In The Matter Plan Change 66 – Rolleston Industrial

OFFICER COMMENTS OF MURRAY ENGLAND

Appendix 3 –
Rolleston Wastewater Network

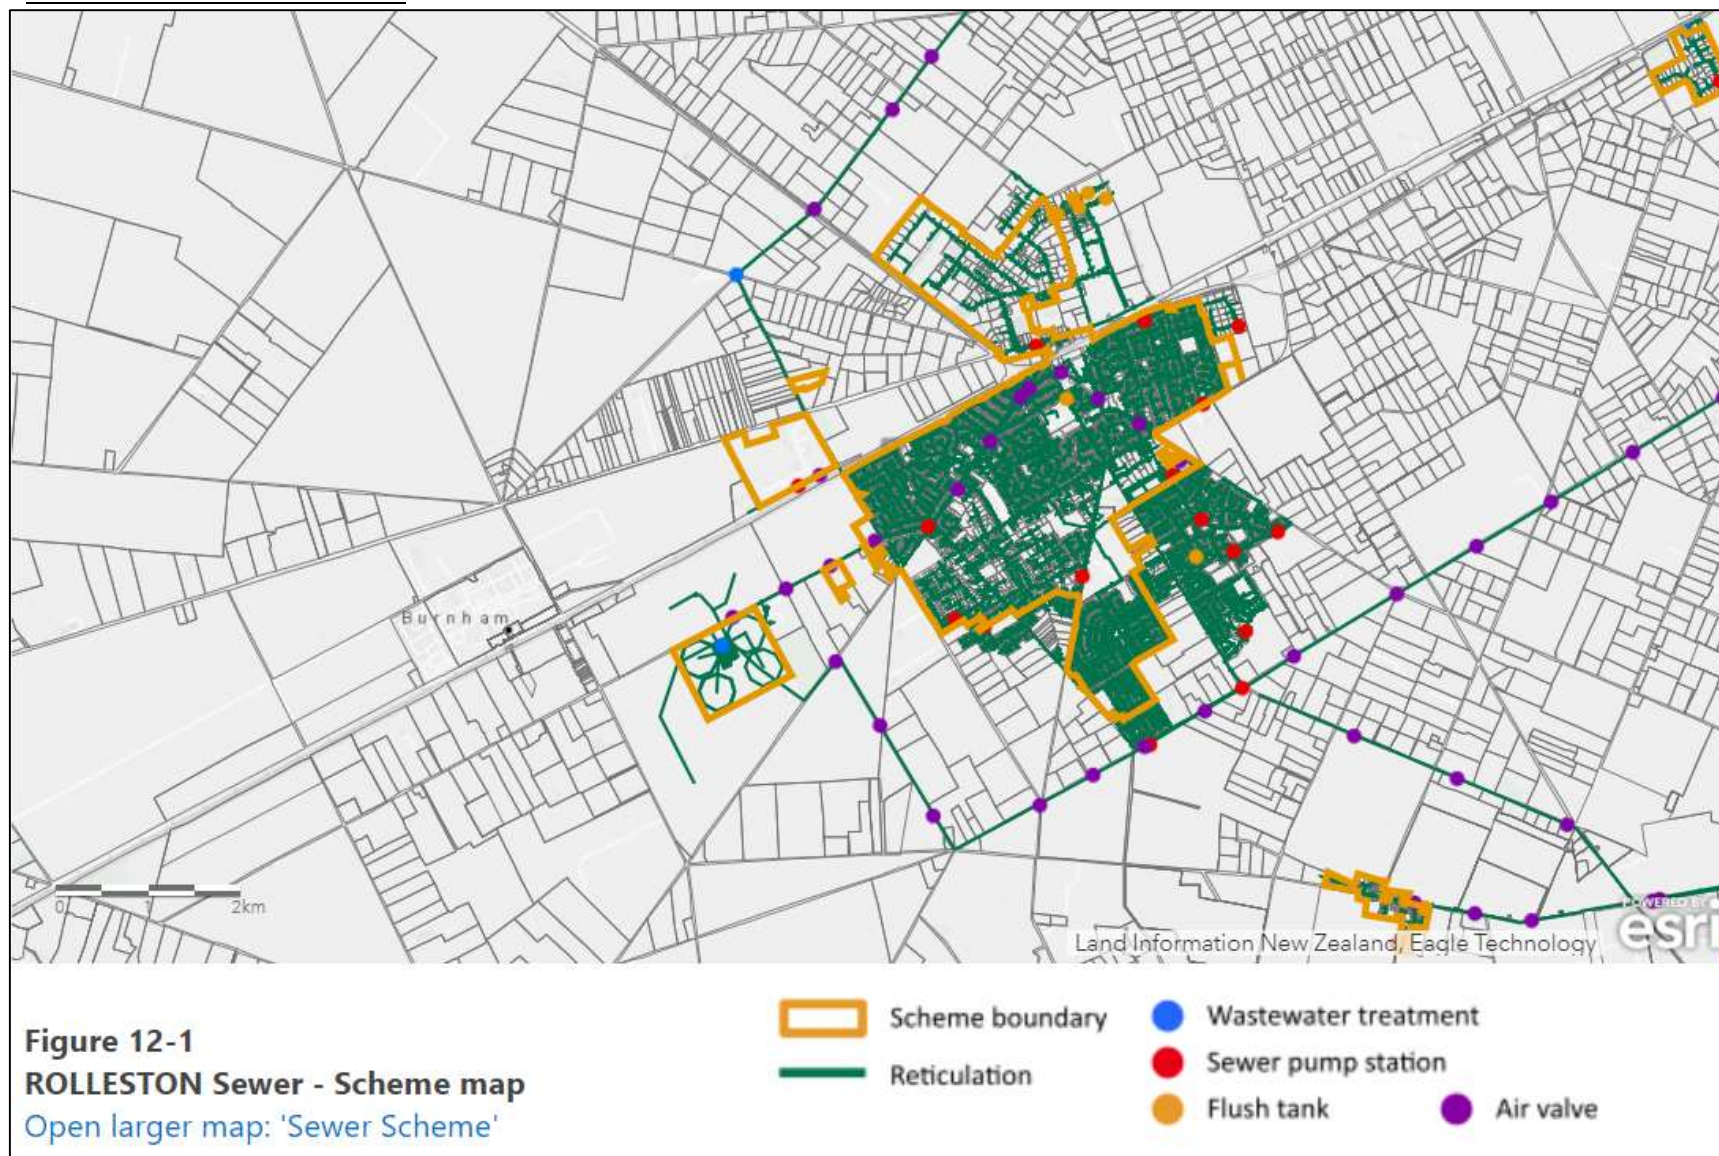
24. Wastewater would be conveyed from the plan change area via local reticulation to the George Holmes Rd pump station which then pumps directly to the Pines wastewater treatment plant (refer appendix 3).
